**GREAT KAROO WIND ENERGY FACILITY
NEAR SUTHERLAND IN THE NORTHERN
CAPE PROVINCE
(DEA REF: 12/12/20/2370/3)**

**MOTIVATION FOR AMENDMENT OF
ENVIRONMENTAL AUTHORISATION**

**AMENDMENT OF TURBINE ROTOR DIAMETER, NUMBER OF TURBINES AND
THE TURBINE GENERATING CAPACITY**

Figure 1: The new proposed turbine layout (A3 Map included in **Appendix F**- the final layout submitted with the Final EIAr is also included in **Appendix F**).

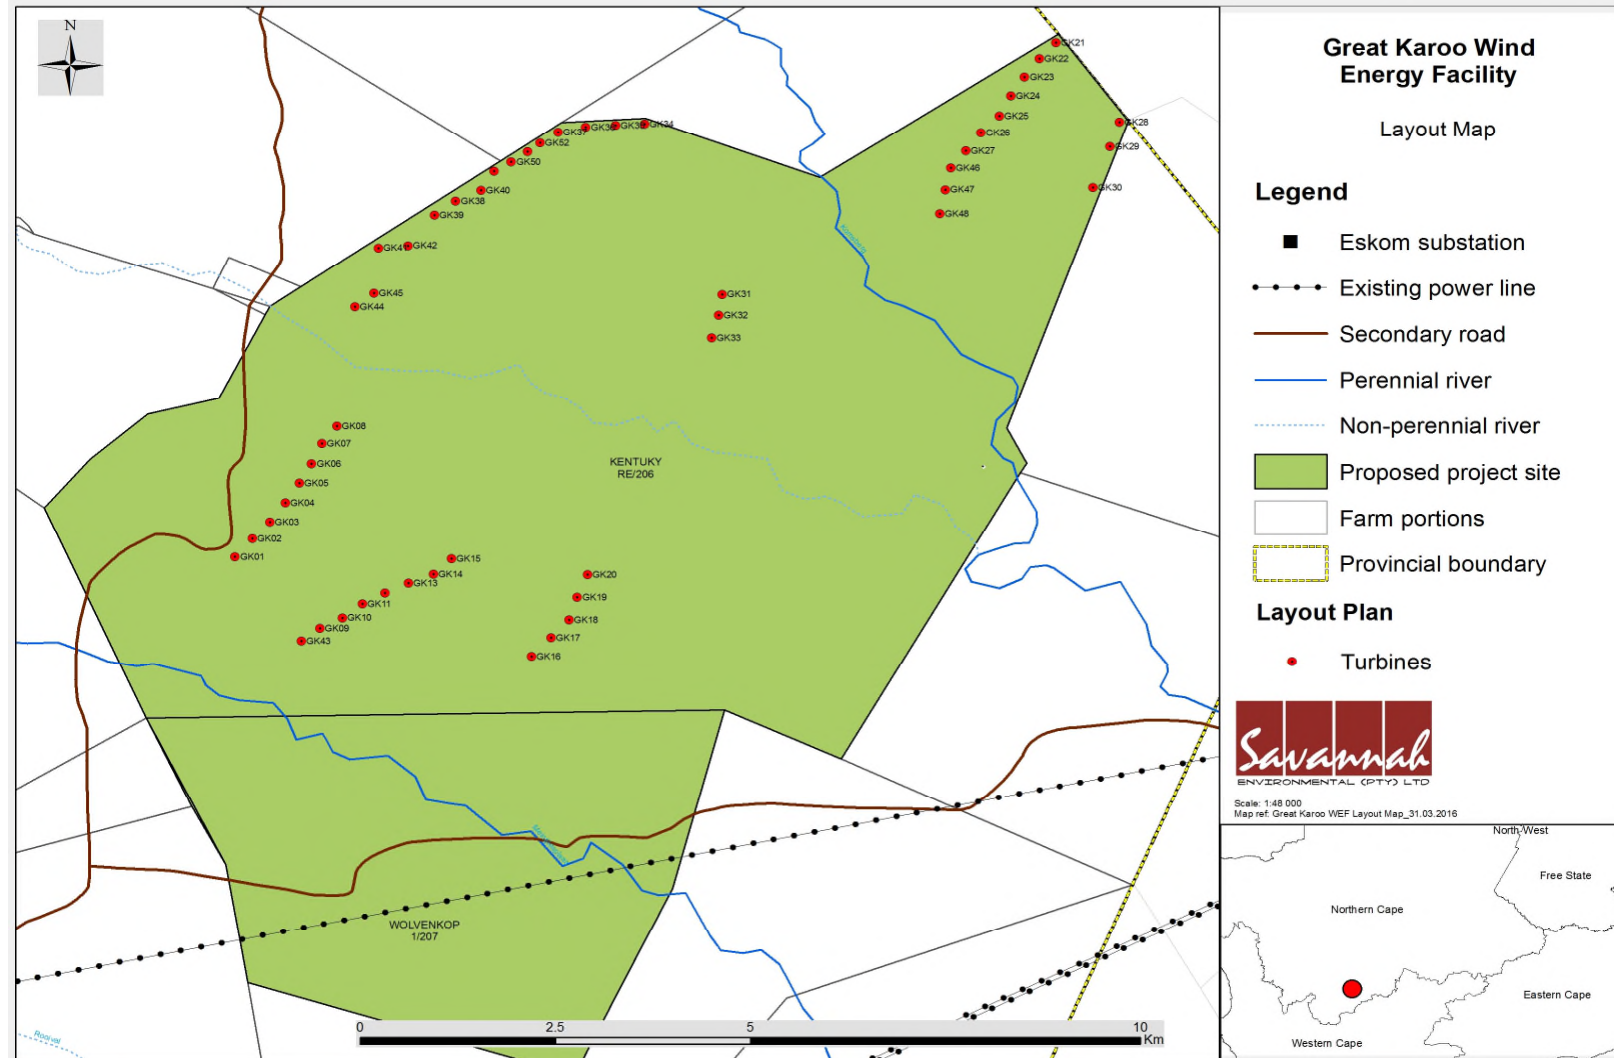
Following developments in technology after the issuing of the EA and in finalising the site development plan on the basis of the wind monitoring results from the site and economic efficiency considerations, the developer is now proposing an increase in rotor diameter from 120m to 140m and the reduction in the number of turbines from 56 to 52 (refer to Figure 1), each with a generating capacity of up to 3.6MW. These changes are proposed in order to increase the efficiency of the facility and consequently the economic competitiveness thereof.

1. The authorised number of turbines is proposed to decrease from 56 turbines to 52 turbines.

The only area where the additional rotor diameter could marginally increase identified impacts is shadow flicker that was identified as a potential threat to a homestead of a project participant that lies within 1km of proposed turbines. The new proposal sees turbine positions removed from the east and north east of the homestead which will reduce the risk of shadow flicker particularly during spring, autumn and winter. Given that the rotor diameter will increase from 120m to 140m with the new proposal and the overall height of the structure will increase by 10m when each blade reaches the top of a revolution, the potential for shadow flicker to affect the homestead will increase marginally. The assessed impact associated with the new proposal is therefore increased from very low to **low**. With mitigation this reduces to **very low**. Please refer to the assessment tables below and the Visual Impact Assessment Addendum Report in **Appendix B**.

Up to 52 wind turbines (with up to 3.6MW in capacity and with up to 140m rotor diameter and a hub height of up to 120m)
